ADDENDUM NO. 3
June 6, 2023

2023 RECONSTRUCT TERMINAL BUILDING
AIP No. 3-27-0025-20-2023
SKY HARBOR AIRPORT
DULUTH, MN

This addendum consists of 2 pages and Drawing Nos. G2.10, C3.00, C4.00, C5.01, A301, S101, S502, and S504.

G2.10

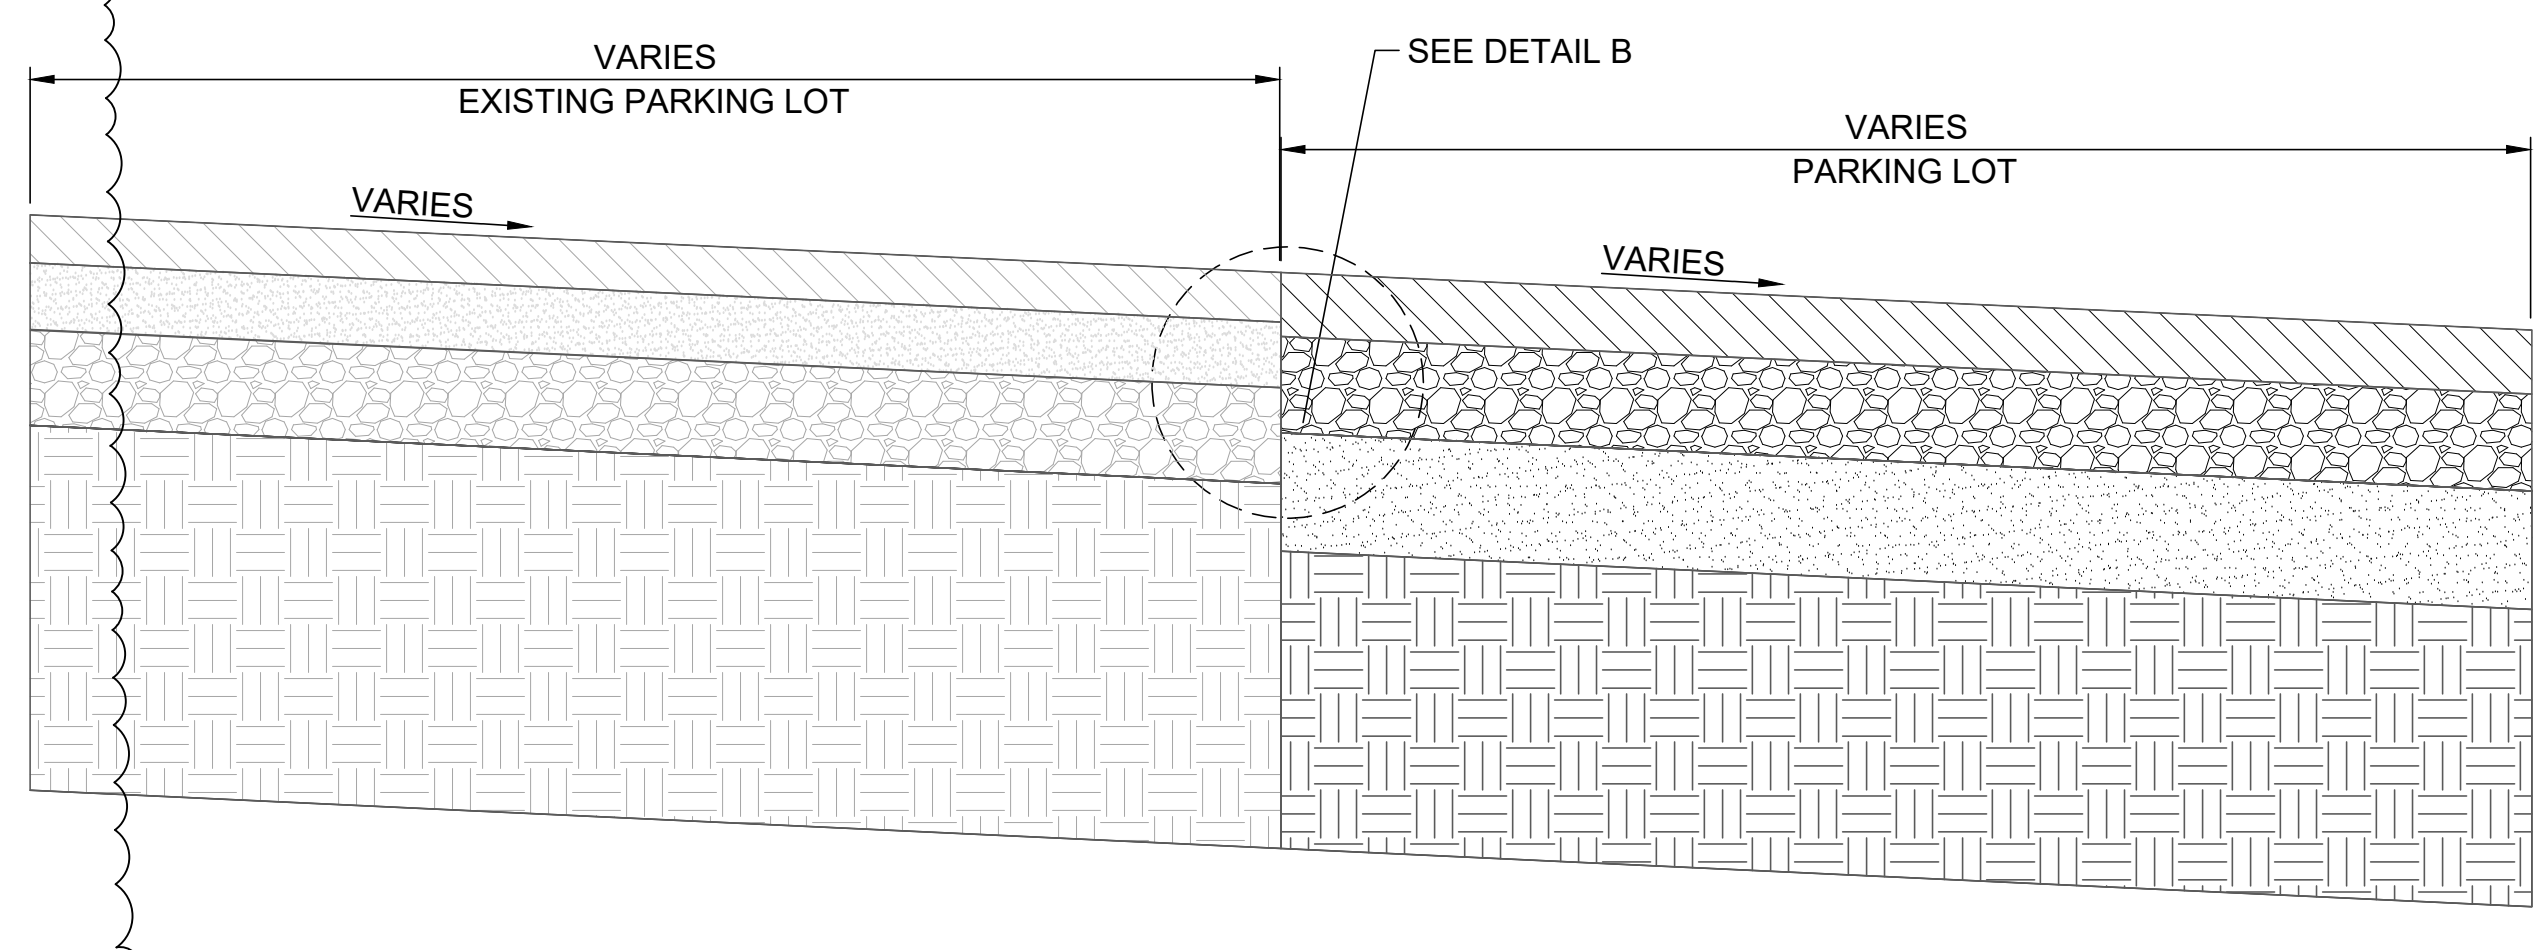
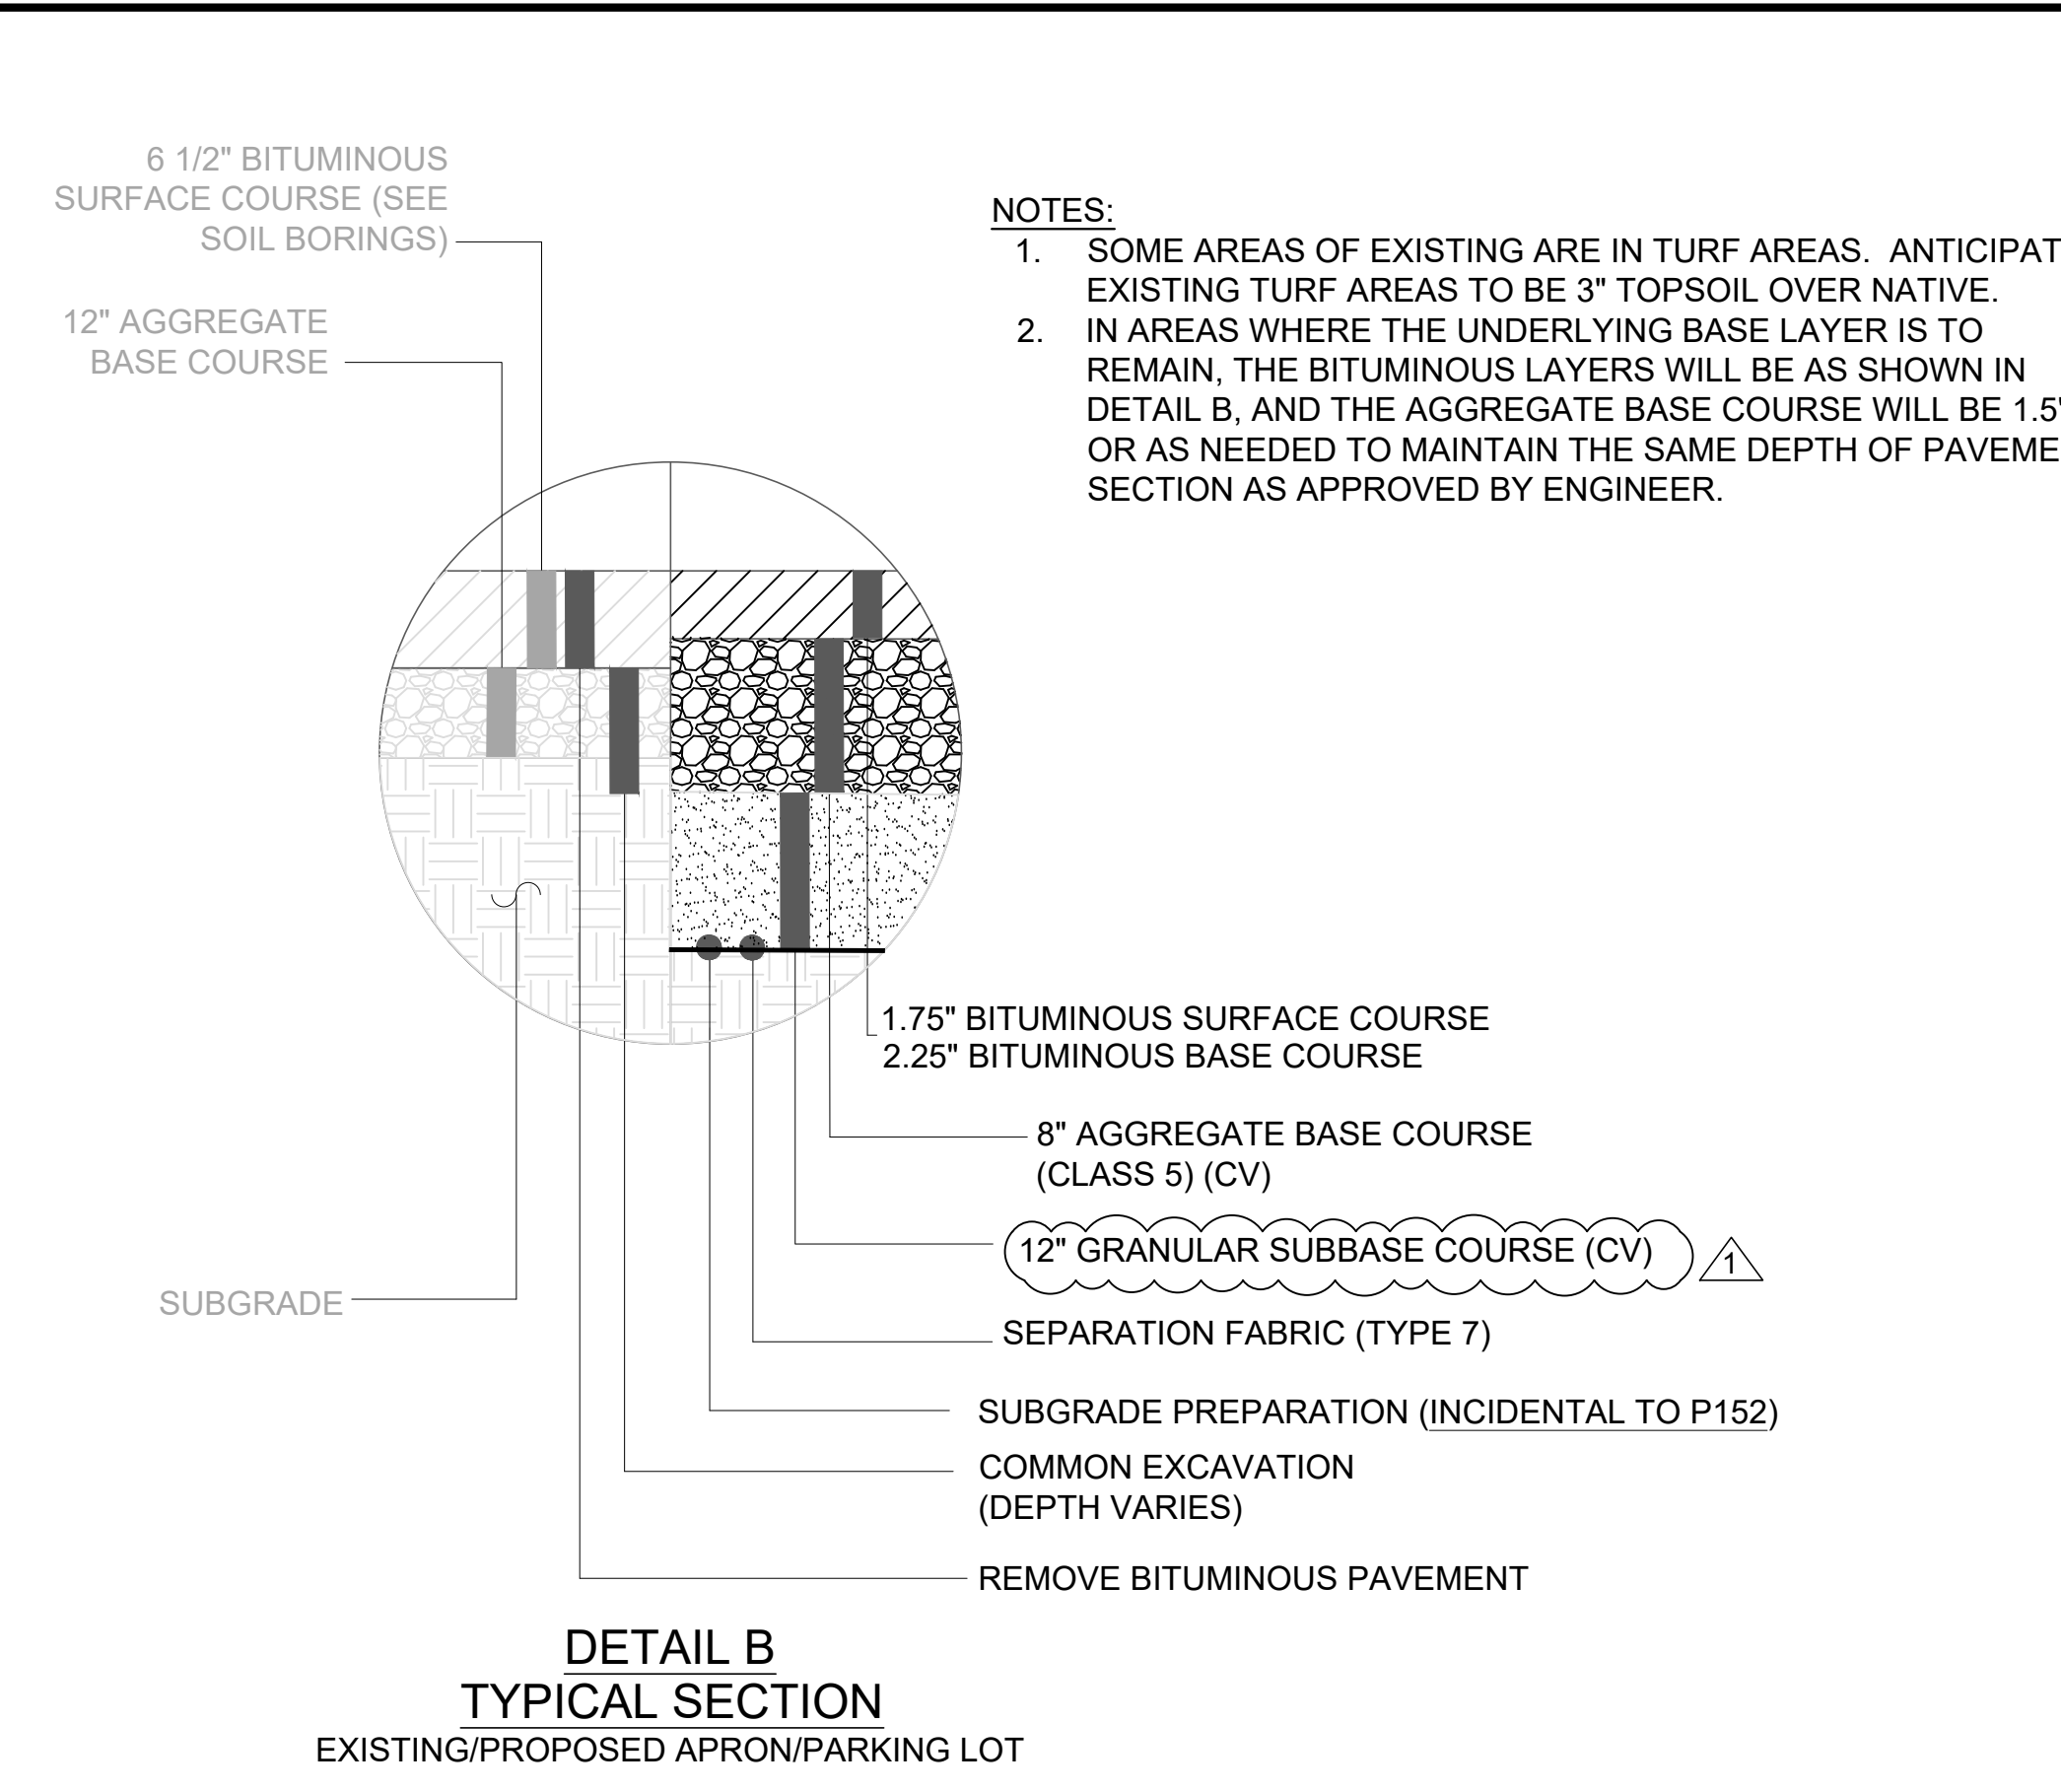
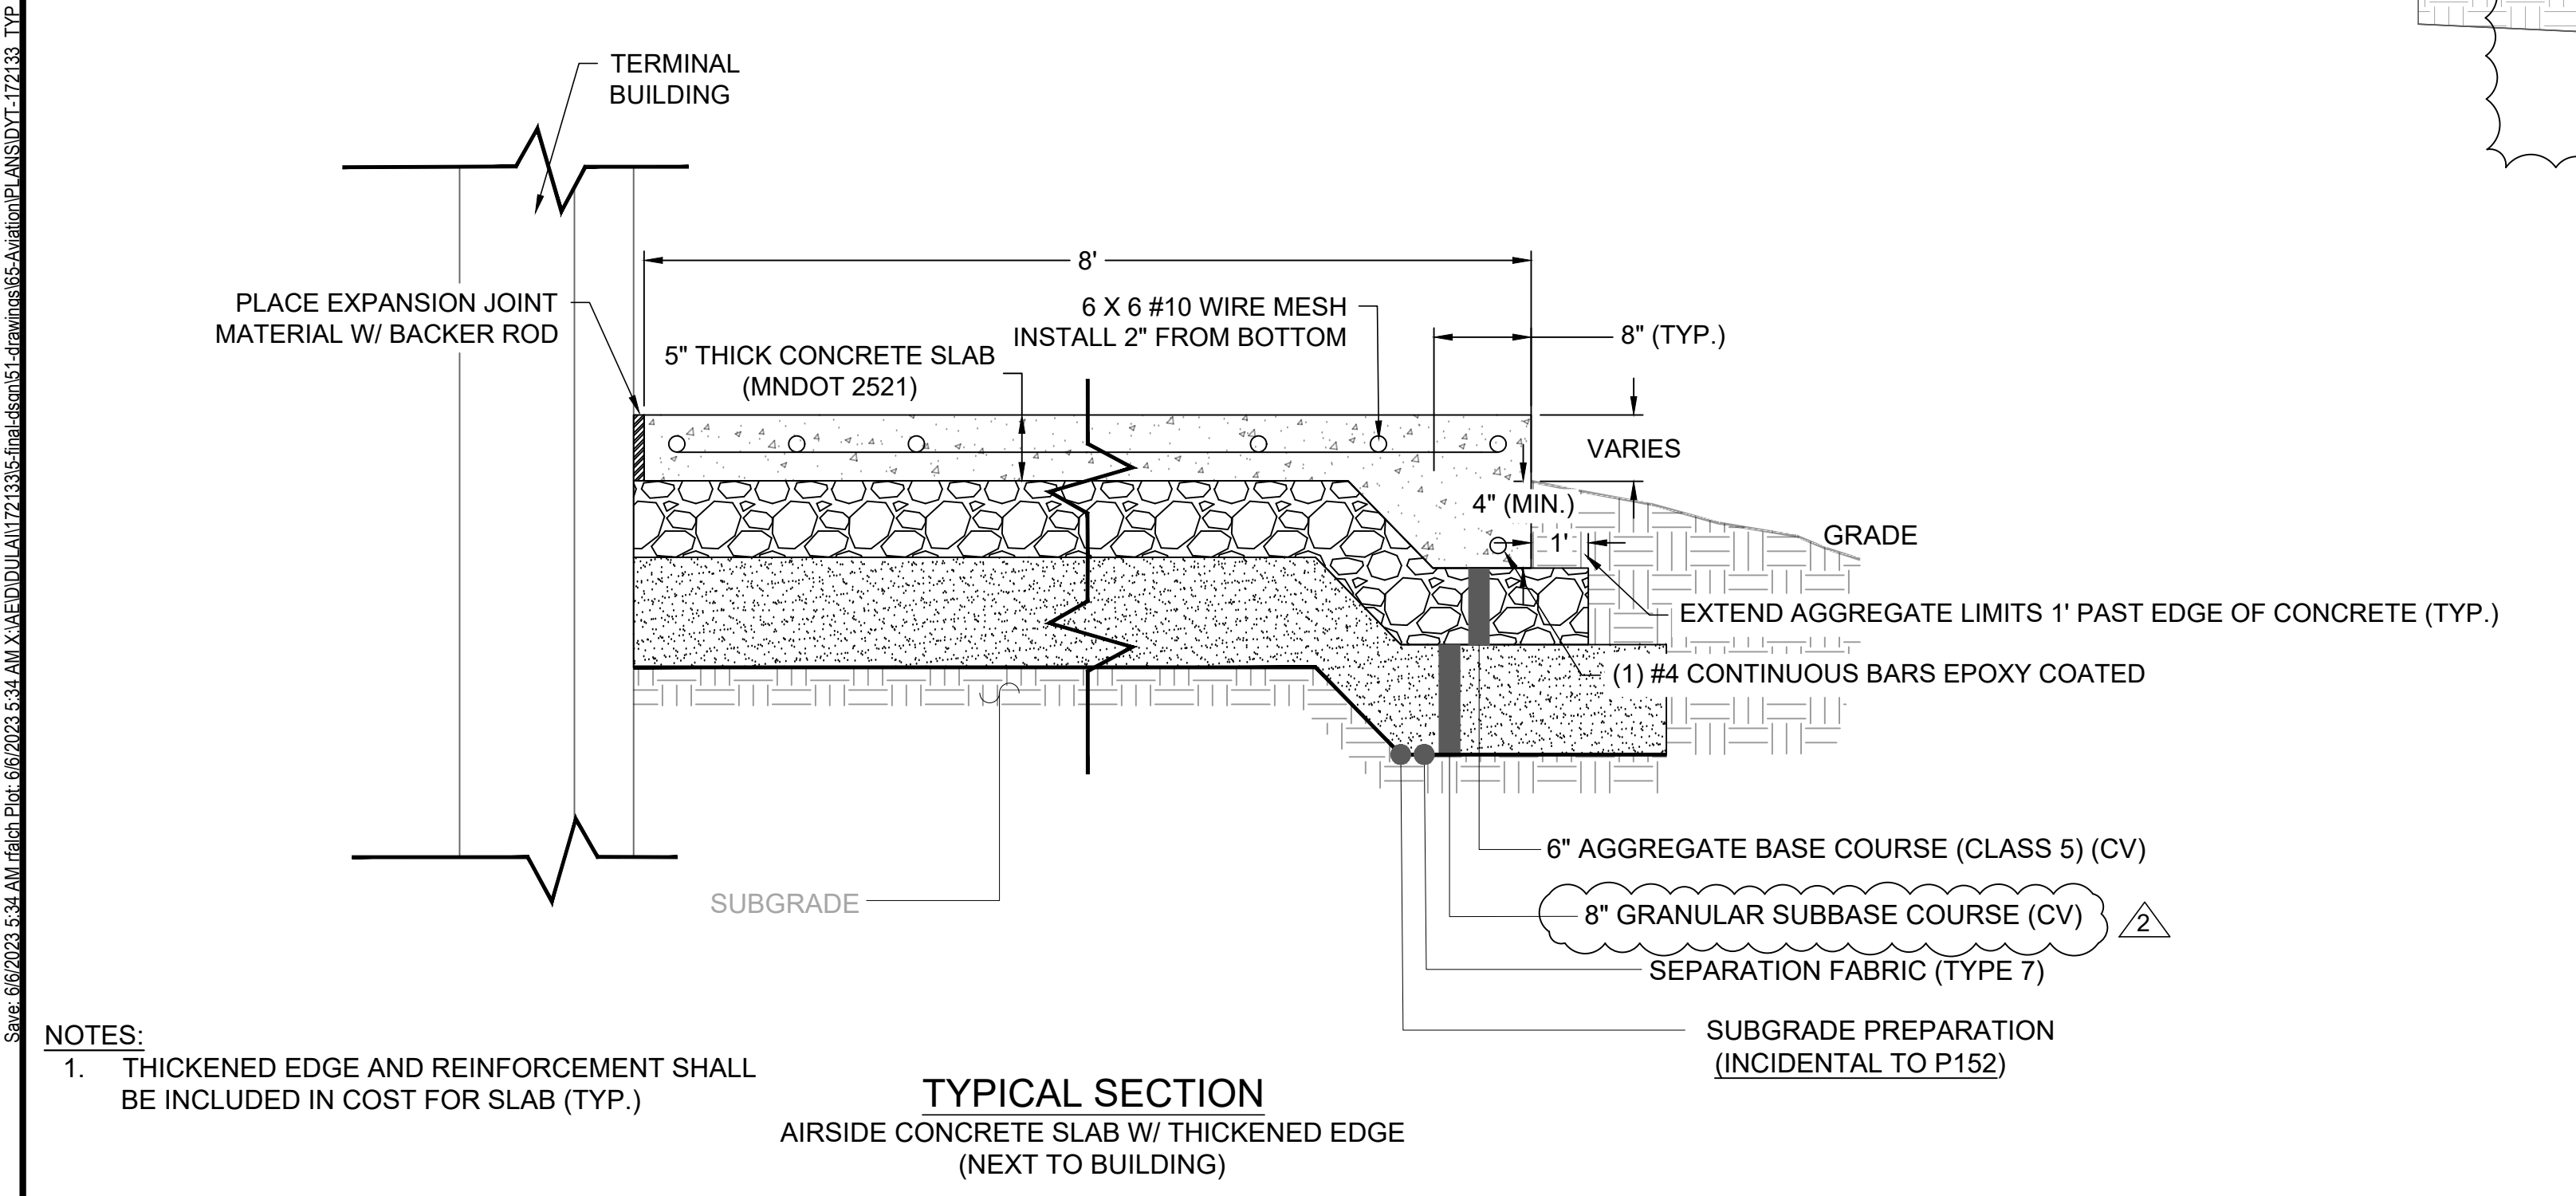
1. Drawing G2.10 – Statement of Quantities, DELETE in its entirety and REPLACE with the attached revised drawing.
 - Updated Quantities and Quantity Notes related to Item No. 39.

- Quantities changed related to Item No.39, for shifting northside sloped walk to structural discipline and shall be covered under Item No. 59.
2. Drawing C3.00 – Typical Sections, Drawing C4.00 – Pavement Plan, DELETE in its entirety and REPLACE with the attached revised drawing.
